**PROPOSED RESIDENTIAL DEVELOPMENT
LAND WEST OF NORMANDY WAY, HINCKLEY**

**SECTION 278 WORKS – OFF-SITE IMPROVEMENTS:
STAGE 1 ROAD SAFETY AUDIT RESPONSE REPORT**

Project Details	
Report Title:	Section 278 Works – Off-site Improvements: Stage 1 Road Safety Audit Response Report
Date:	11/08/2023
Document reference and revision:	C21021-RSARR1-01
Prepared by:	Capricorn Transport Planning Ltd
On behalf of:	Bloor Homes

TITLE
PROPOSED PEDESTRIAN/CYCLE CROSSING AT OUTLANDS DRIVE

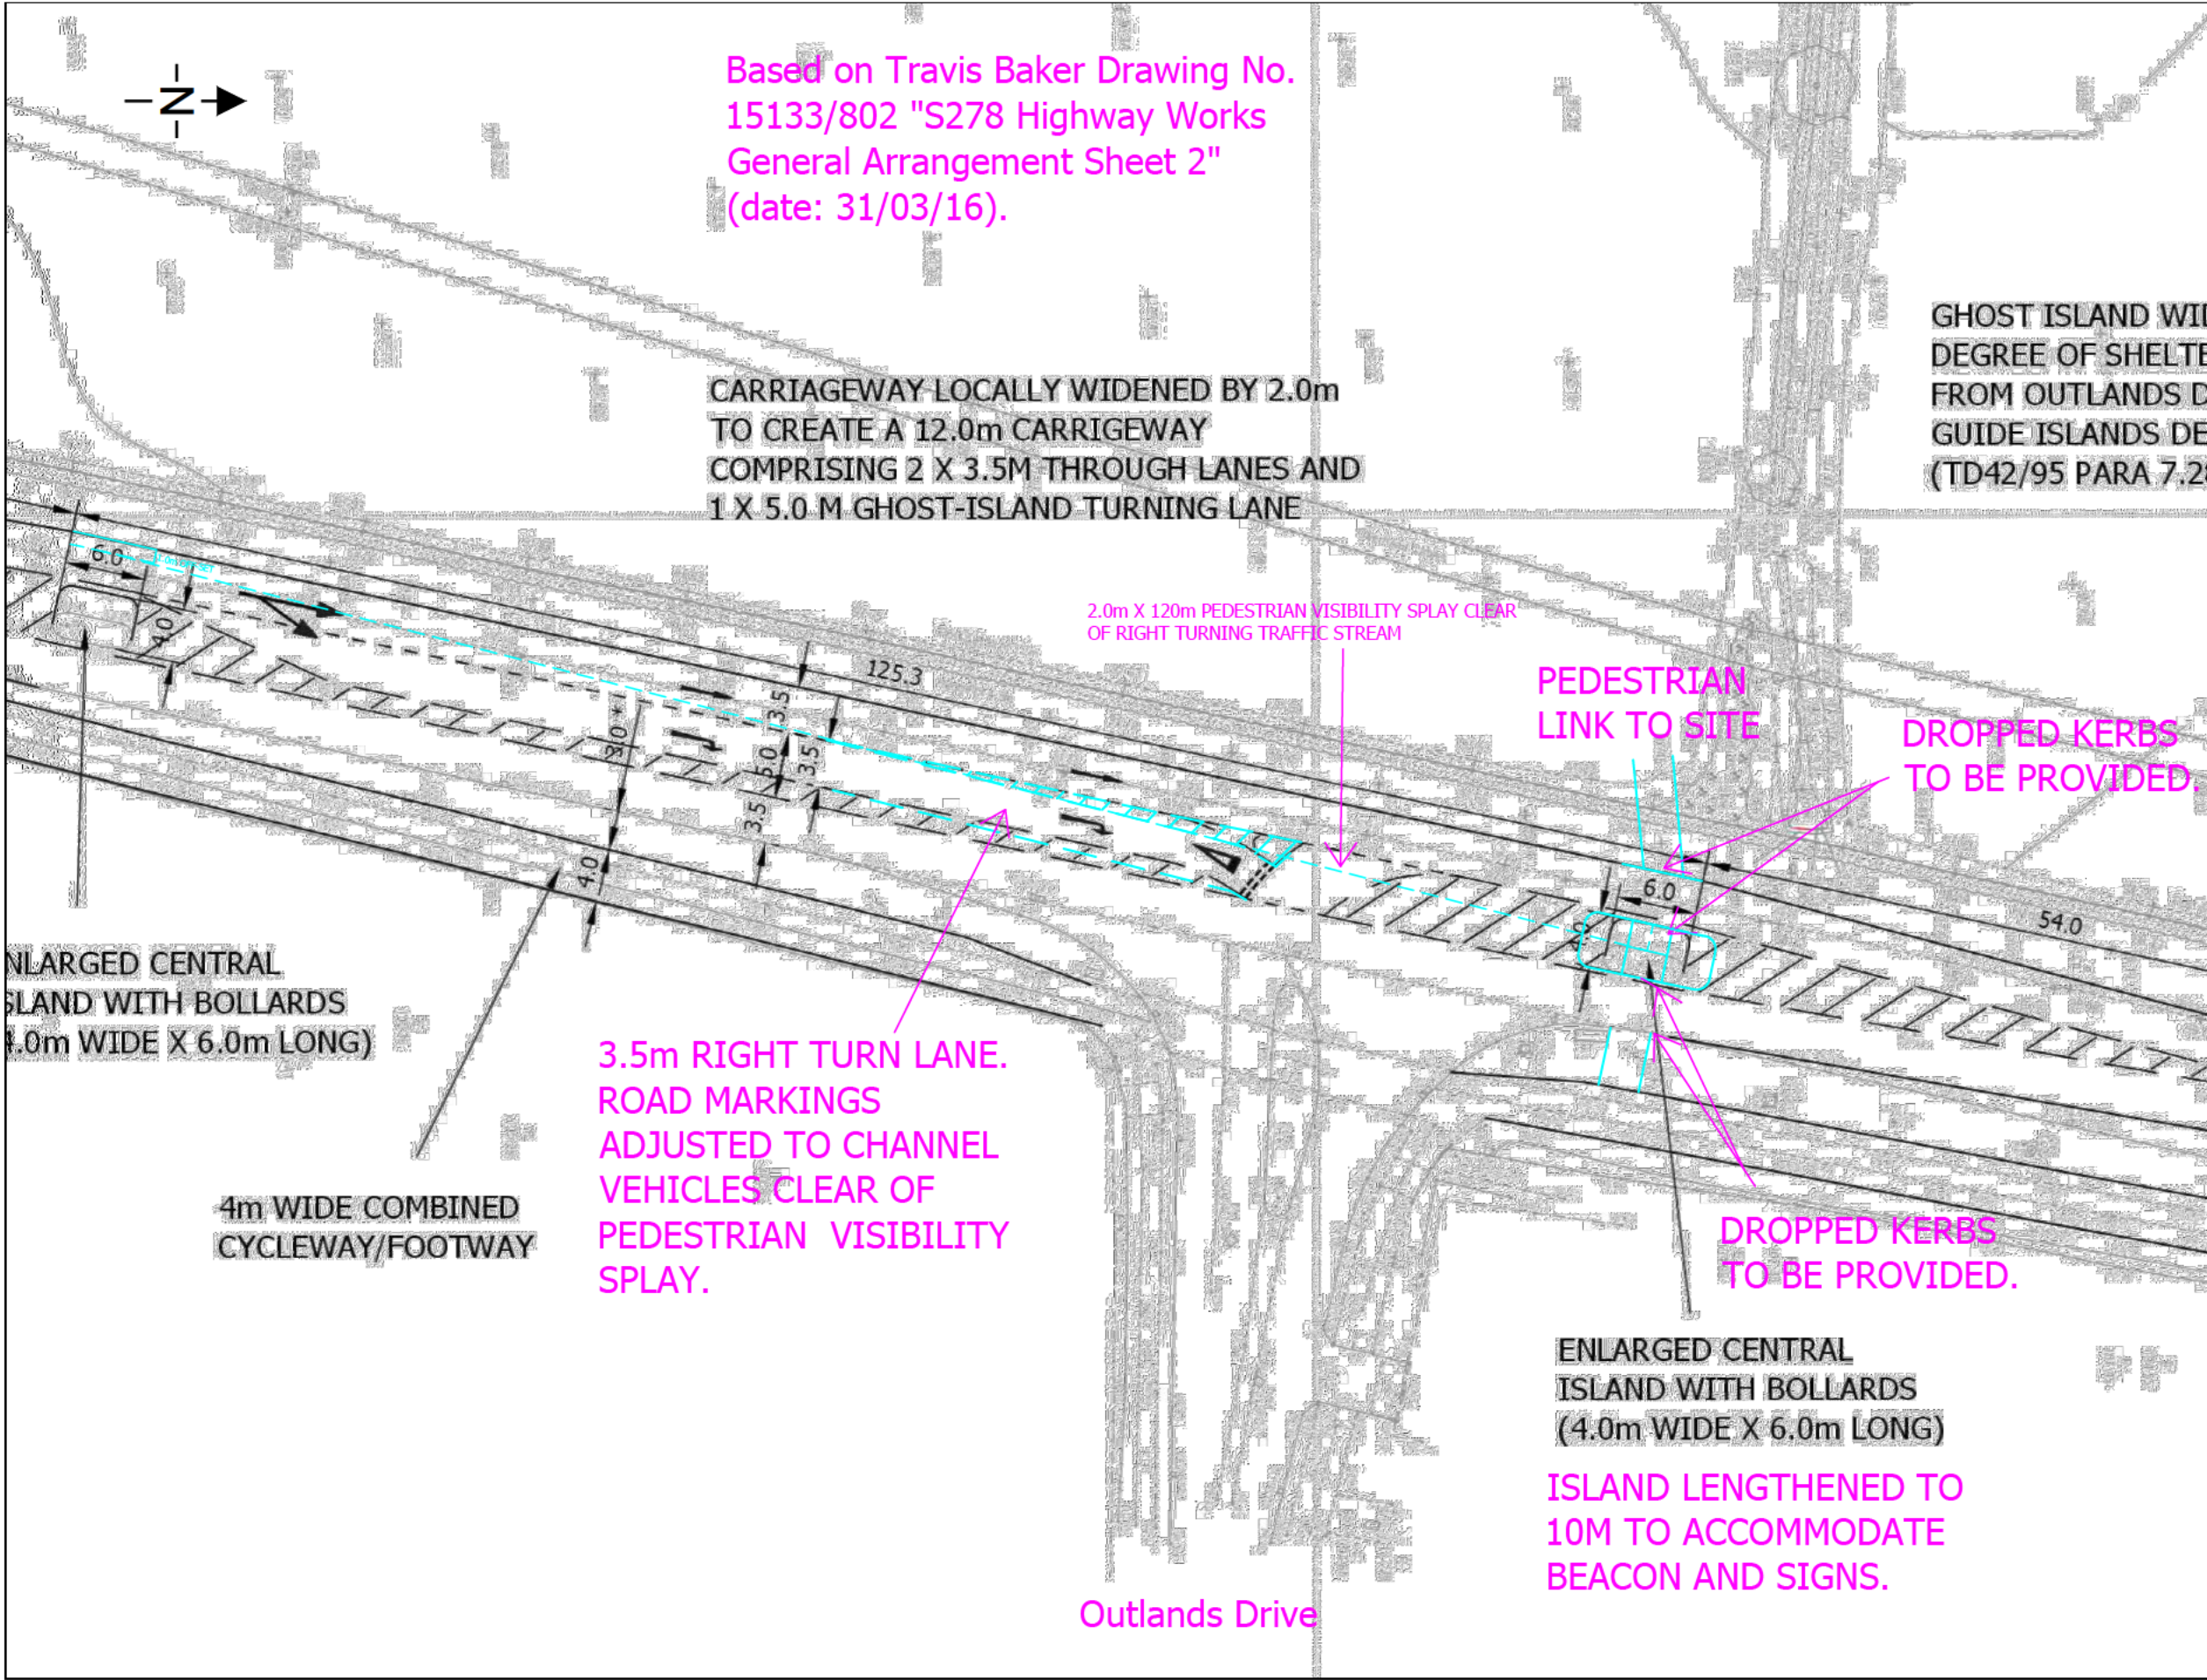
RSA problem	6.2 The proposed refuge will be close to the right-turn lane and reservoir for Outlands Drive. Vehicles waiting in the lane/reservoir may obstruct pedestrian visibility. If pedestrians cannot see approaching vehicles (and vice versa), then they may step out in front of live traffic, risking a collision.
RSA recommendation	It is recommended that the pedestrian facility is sited so that appropriate visibility is maintained.
Design Organisation response	Accepted. A pedestrian visibility splay of 2.0m x 120m from the refuge looking towards the south along Normandy Way, consistent with the current 40mph speed limit, is shown on Drawing C21021/DR002 (Rev. A). The road markings within the right turn lane area have been adjusted to ensure that the vehicle queuing area is clear of this visibility splay. The revised drawing is presented in Appendix A .
Overseeing Organisation response	
Agreed RSA action

REV	DESCRIPTION	DATE	BY	AUTH
A	PEDESTRIAN VISIBILITY SPLAY ADDED AND ROAD MARKINGS ADJUSTED IN RESPONSE TO RSA.	11.08.23	SM	SAM
